TOWN OF GRAFTON, VT CAMBRIDGEPORT BRIDGE

PROPOSED IMPROVEMENT BRIDGE PROJECT COUNTY OF WINDHAM VT ROUTE 121, BRIDGE NO. 16G

RECORD PLANS	
CONTRACTOR:	F.W. WHITCOMB CONSTRUCTION CORP. - WALPOLE, NH
RESIDENT ENGINEER:	CHAD GREENWOOD
CONSTRUCTION BEGAN:	APRIL 11, 2006
CONSTRUCTION COMPLETE:	MAY 11, 2007
RECORD PLANS BY:	CHAD GREENWOOD & AMOS KEMPTON
I HEREBY CERTIFY THAT ALL THE CONSTRUCTION REQUIRED BY THIS SET OF DRAWINGS HAS BEEN ACCOMPLISHED AS INDICATED HEREIN.	
BY:	RESIDENT ENGINEER
DATE:	1/23/12
NOTE: Any further information concerning final quantities, amounts or other details relative to this project may be found at Central Files in the electronic archives.

THIS SHEET SUPERSEDES CONTRACT PLAN SHEET 1 DATED 6/05. REVISIONS ON THIS SHEET REFLECT CHANGES IN DESIGN AND DETAILS AS PER CHANGE ORDER NO. 2, SUBSTITUTING NEW STEEL BEAMS FOR RECYCLED BEAMS.

ELEVATION

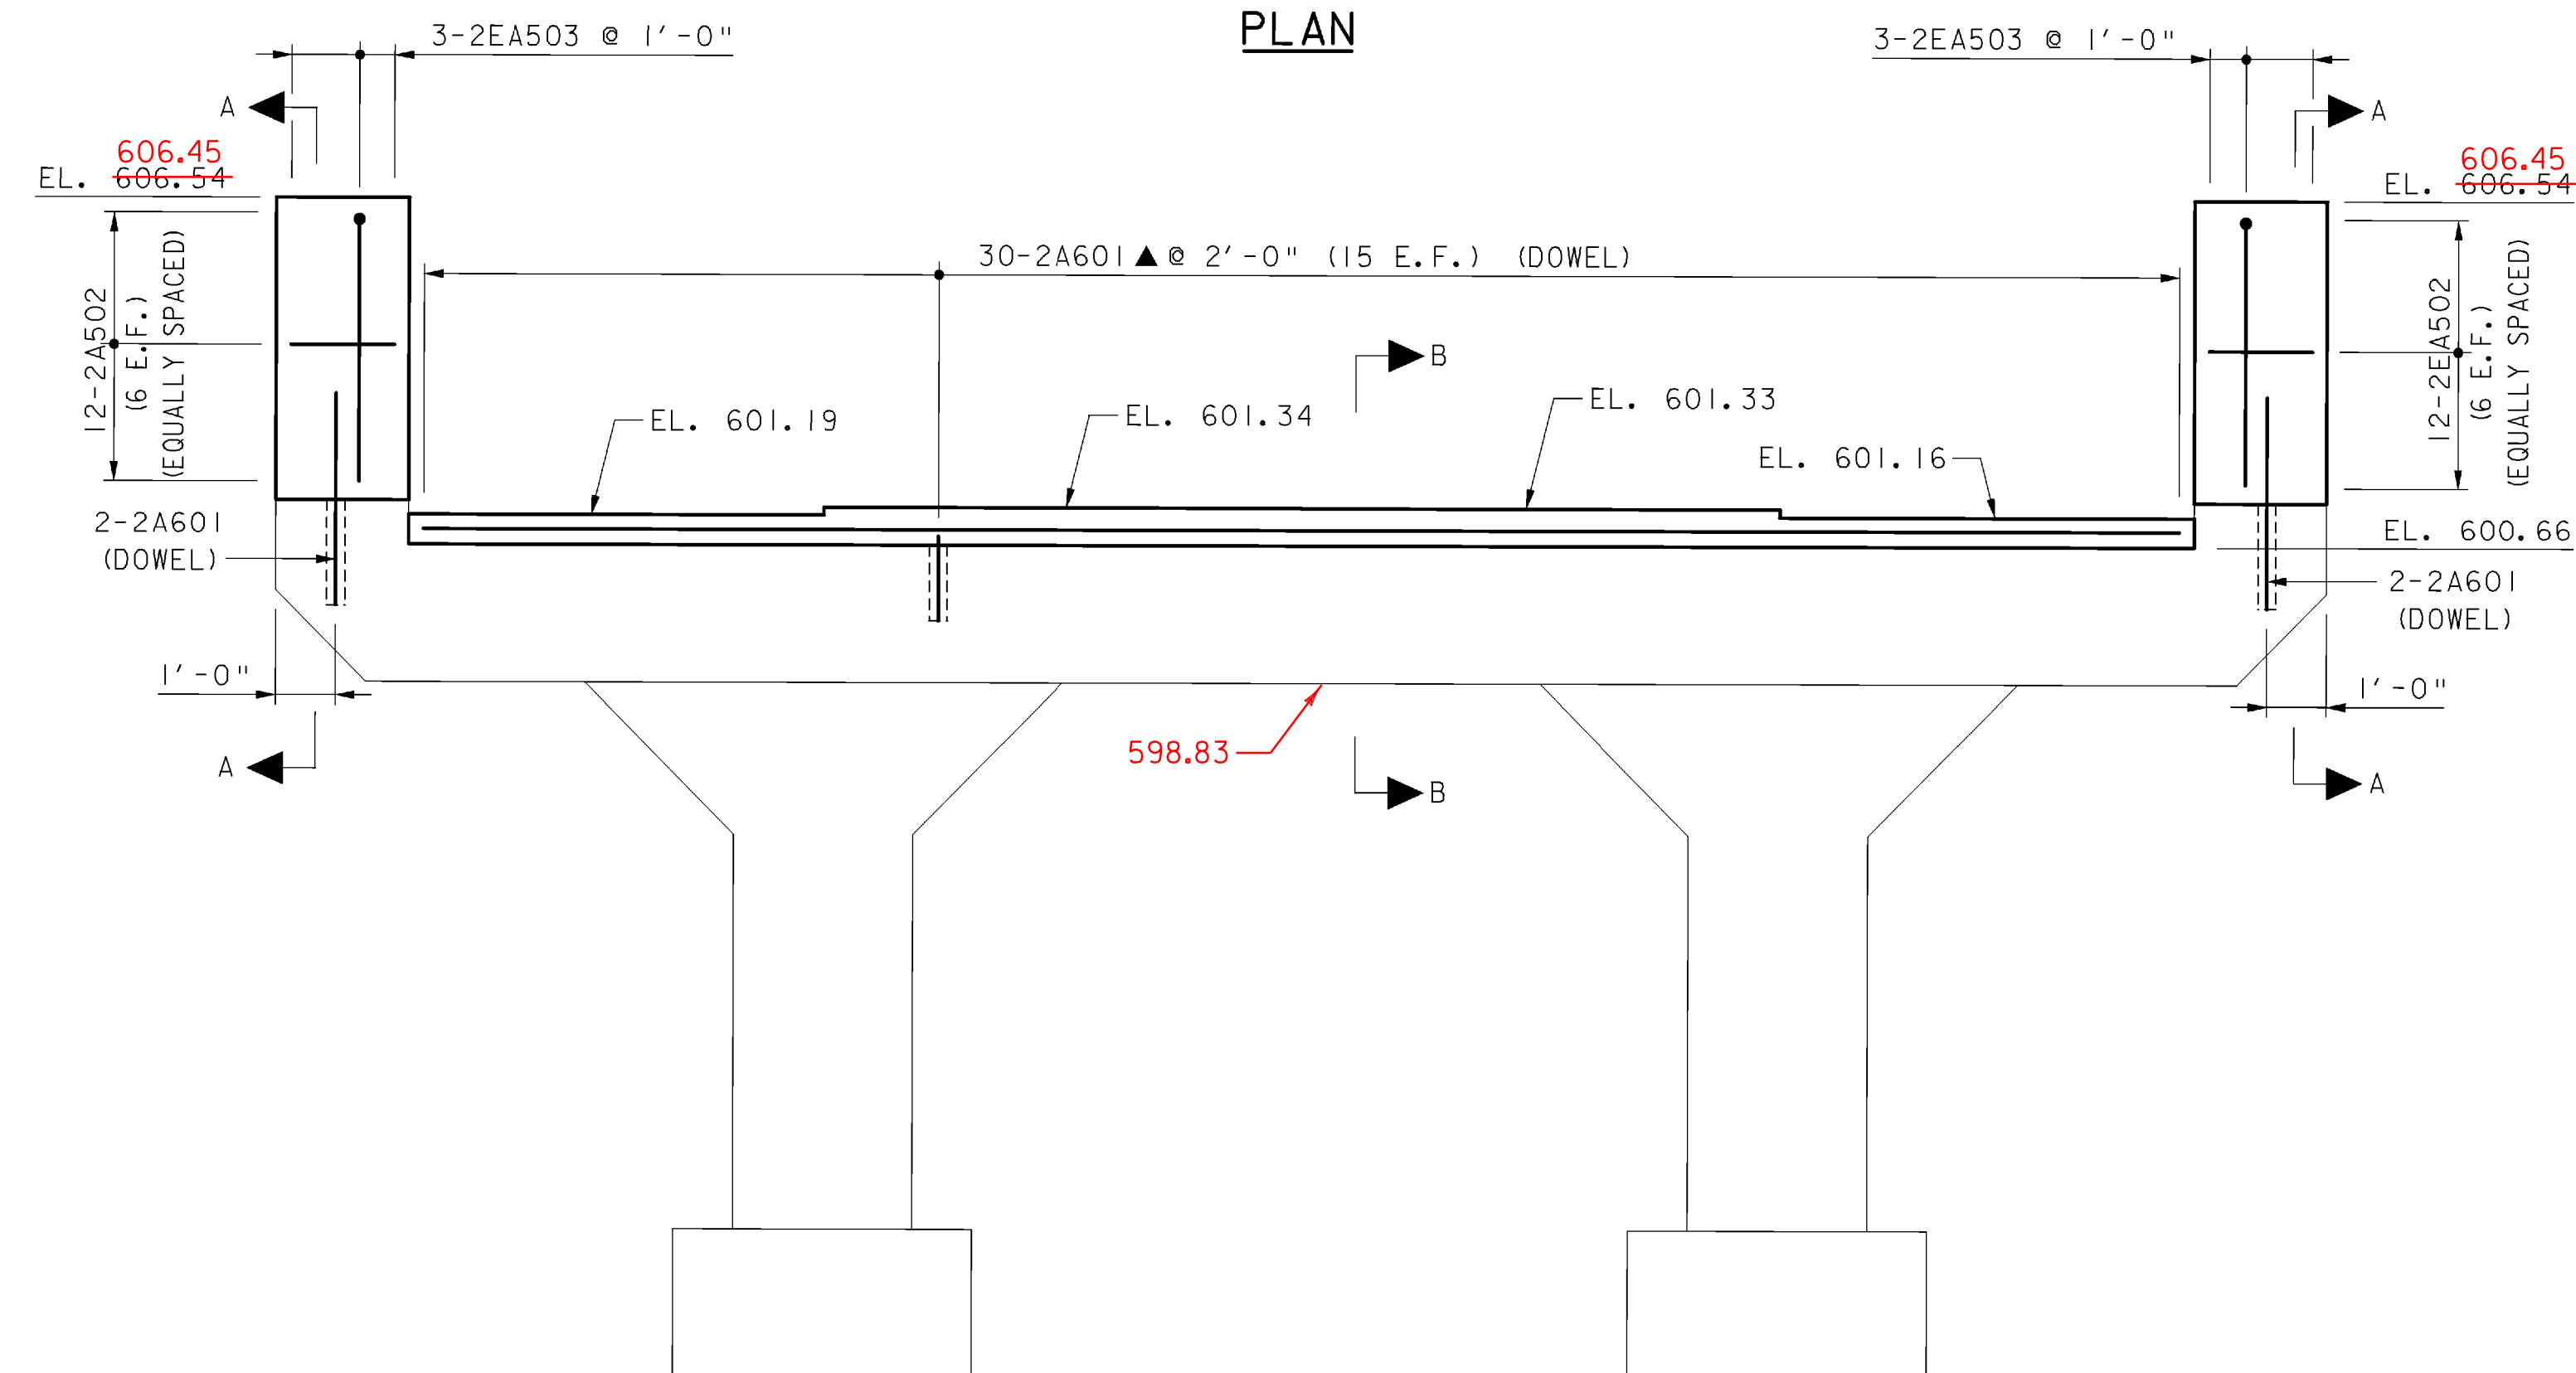
THIS SHEET SUPERSEDES CONTRACT PLAN SHEET 35 DATED 6/05. REVISIONS ON THIS SHEET REFLECT CHANGES IN DESIGN AND DETAILS AS PER CHANGE ORDER NO. 2, SUBSTITUTING NEW STEEL BEAMS FOR RECYCLED BEAMS.
